Armagh East Link

Proposed Options Workshop Report

1064968/0000/R/0001
Version 3.0

Scale @ A1	Not to Scale	Ver.
Drawing No.	1064968-A-D-0810	A

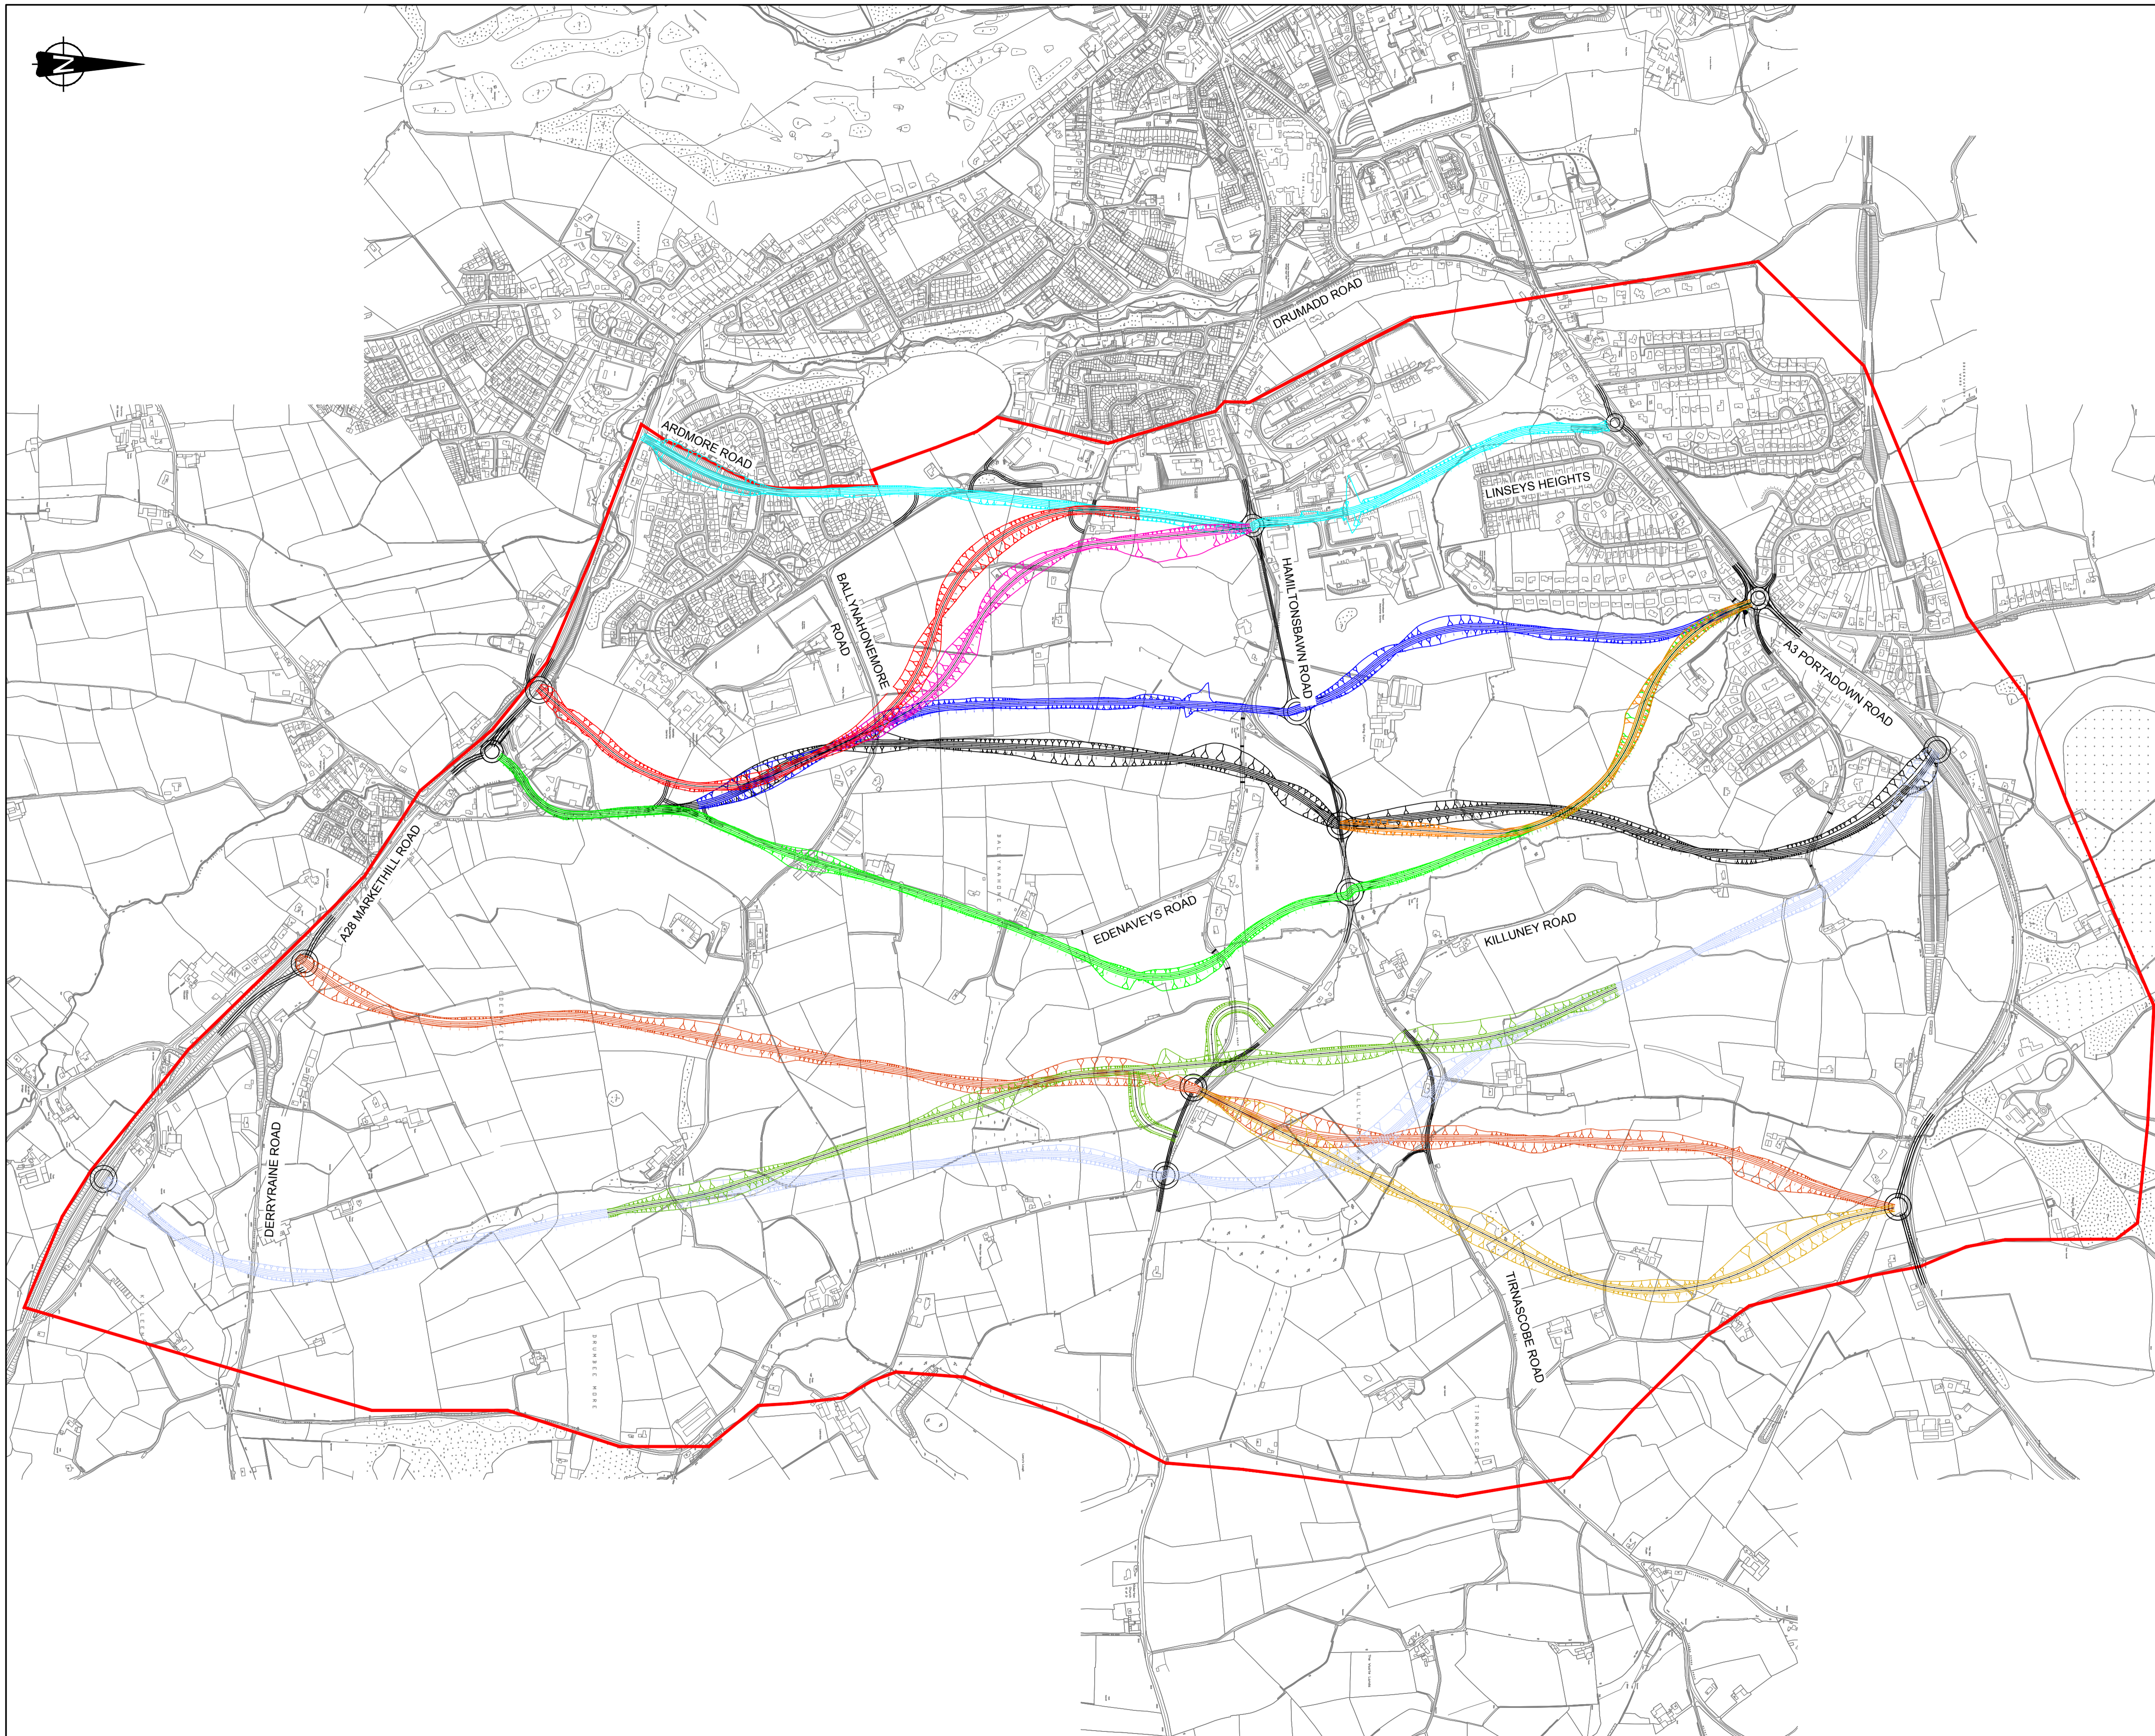
A Red/Amber/Green assessment was undertaken against criteria ii) to x) above to highlight key issues and concerns. Key findings from the workshop assessments and discussions under the above headings included:-

- a) Horizontal Alignment: no significant issues were identified, although Options 20 and 50 incorporate slightly more onerous design parameters or require further design input to refine further.

- b) Vertical Alignment: no significant design issues were identified; Option 50 was rated Amber due in part to the combination of vertical design with horizontal design parameters.

- c) Junction Issues: no fundamental issues were identified, however Options 40 and 50 were rated Amber due to the inclusion of roundabouts at the southern end of their alignments where the options meet the A28; Option 14 was rated Amber due to the complexities and impact associated with connecting that route option to Hamiltonsbawn Road.

- d) Side Road Issues: no fundamental issues were identified; Option 50 was rated Amber as it proposes stopping up Killuney Road either side of the route option close to the route option's northern end.

- e) Overtaking Issues: the 2007 Preferred Option and Options 15 and 16 do not provide overtaking sections, however, this is consistent with their lower design speeds and more urban settings; overtaking sections could be provided on the other route options.

- f) Earthwork Issues: Option 11 was rated Red as it was estimated to have an unsuitable earthworks balance that would lead to a significant volume of surplus material; Option 14 was rated Red as it was reported to have an even more onerous deficit in material – some scope existed to reduce this deficit but it was considered that that could lead to some further adverse impacts.

- g) Drainage Issues: no fundamental issues were identified, albeit the 2007 Preferred Option and Options 15 and 16 were rated Amber as the impact of their drainage requirements on the existing A28, A51 and/or A3 drainage systems would require further investigation.

- h) Property Issues: Options 13 and 20 were rated Red due to property issues; the 2007 Preferred Option, Options 10, 14, 15, 16, were rated Green; the other options were rated Amber.

- i) Client Workshop Feedback: Options 11, 14 and 20 were rated as Red, due to the combination of issues in each respective option, and, their lesser design characteristics and/or increased impacts compared to other similar options as discussed further below.

- Option 11 was discounted in favour of Option 10 due to the less onerous earthworks and gradients associated with Option 10 and lesser severance and impacts on existing farm settlements.
- Option 14 was discounted in favour of Option 13 due to the less onerous earthworks with Option 13 and the requirement to bridge Option 14 over Hamiltonsbawn Road: the resulting link roads connecting Option 14 to Hamiltonsbawn Road would also add to Option 14's impacts.
- Option 12 was favoured over Option 20 due to more onerous property impacts associated with Option 20, and, private accesses that would need to be connected onto Option 20 would be on an overtaking section of carriageway. Options 40 and 50 were also considered to be more favourable than Option 20.
- Option 15 was discarded in favour of Option 16 due to more onerous earthwork impacts and the greater impact on residential dwellings.

It was concluded that four route options should be taken forward for further consideration and reported upon within the pending Route Assessment Report, specifically:-

- **2007 Preferred Option:** This option was previously identified as the preferred option following a more detailed assessment than that which has more recently been undertaken and therefore remains a candidate for assessment; no new information has been received that would omit this option from further consideration at this time.
- **Option 16:** This option offers a viable *inner option* alternative to the 2007 Preferred Option and was one of those developed as a response to comments received at the last Public Information Day held in June 2014; the option has the potential to be amended to tie in to the A28 via the A28’s junction with the Edenaveys Industrial Estate.
- **Option 50:** This option offers a viable *central option* that ties in to the A3 at the proposed tie-in point for the North-West Link to the A3; the traffic and

economic implications of such an option should be considered further, given that an engineering option is potentially viable.

- **Option 12:** This option offers another *central option*, is a viable engineering option and, without prejudice to its own assessment, would be a useful comparator in any assessment of the other three options, located as it is between the 2007 Preferred Option and Option 16, and, Option 50.
